Staff Report for Heritage Richmond Hill Meeting

Report Number: SRPI.21.103

Subject: **SRPI.21.103 – Heritage Permit Application for 53 Arnold Crescent (The McNair-Stallibrass House) – File D12-07010**

Figure 1: Floorplan showing the existing rear door circled in green on the left, and a floorplan showing the proposed new rear door circled in green on the right.

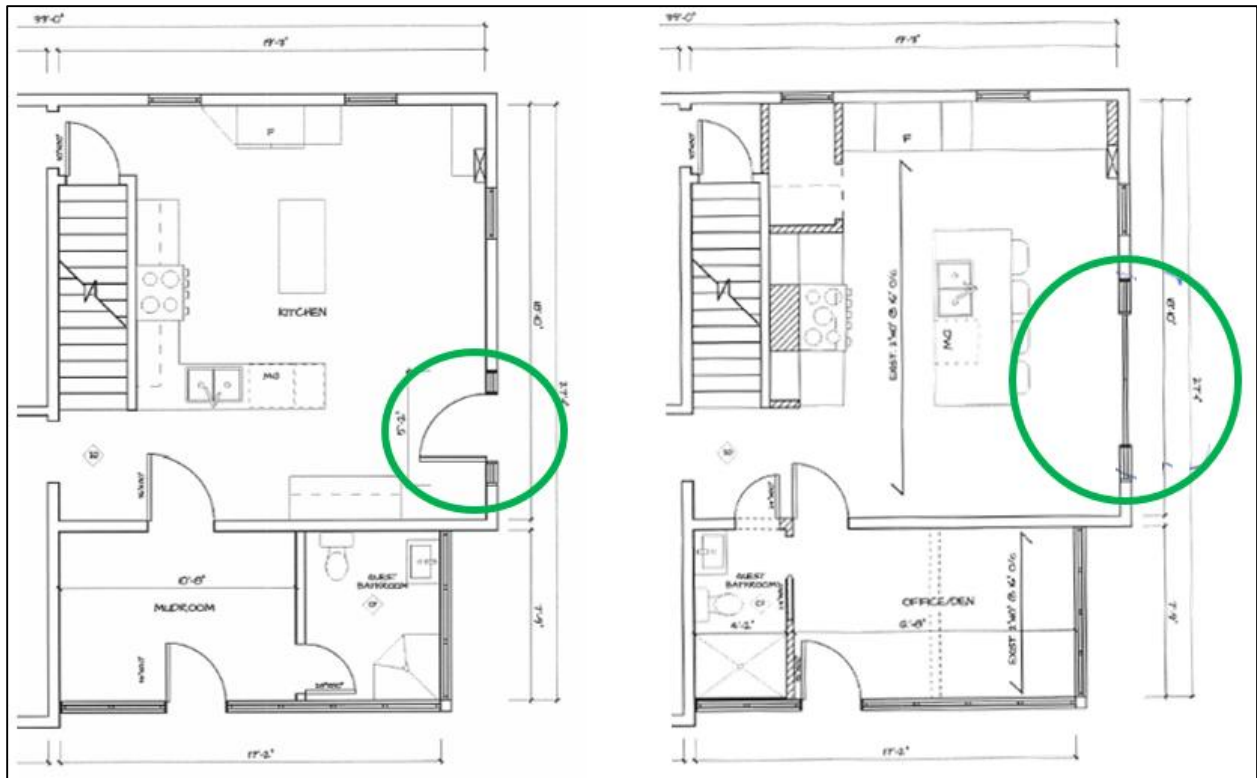
The owner of the Subject Property is proposing to alter the existing rear doorway by removing the existing door and sidelights and installing new French doors with sidelights (see Appendix A and Figures 1 and 2). This will require the owner to remove approximately 4 feet of wall to the right of the existing door (see Figure 1). The owner proposes to paint the new doors Heritage Red (HC-181), which is from Benjamin Moore’s Historical Collections colour palette.

The rear door is not original and is not identified as a heritage attribute. The portion of wall being proposed for removal to allow for a wider door has previously been altered. Accordingly, there are no physical impacts to the heritage attributes of the McNair-Stallibrass House.

The existing door is not original to the house and its asymmetrical design detracts from the design of the rear façade; a symmetrical door will be more complementary to the building's design. The door's location at the rear of the house also means that it will not be visible from the public realm. Accordingly, the proposed alteration to the rear door will have a limited visual impact on the property's heritage attributes.

- a) That the Heritage Permit Application to replace the rear door, as described in report SRPI.21.103, be approved.
